***Unitary Products
Technical Services
Service Letter***

Letter: **YS-004-2017**

Subject: **Non-Condensing; 80k Btu; Burner Ignition Issue**

Pre March 2017 ignitor position

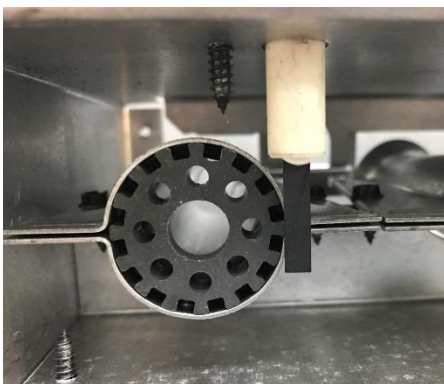
This heating season we experienced an increasing amount of inquiries on the subject model furnaces that would not light. A review of the reports of this issue along with site visits showed that it was predominately found on the 80k Btu model. Based on this information, our engineering team worked on relocating the ignitor closer to the center of the burner opening as well as closer to the face of the burner.

The four cell (80k Btu burner) was reworked with the tooling change being completed in late February. So any 80k Btu model listed above that was produced from March 2017 forward (serial number date code W1C7) will have the ignitor in the new position. To maintain consistency among the production of the burners, we decided to relocate the ignitor position on all 80% & 90% furnace models. The dies for the other furnace models are being reworked and we expect to have all the die work completed in the next several weeks.

Below are pictures of the ignitor in the pre March 2017 production units and a picture showing the new location on units produced in March 2017 going forward.

March 2017 and forward Ignitor Position
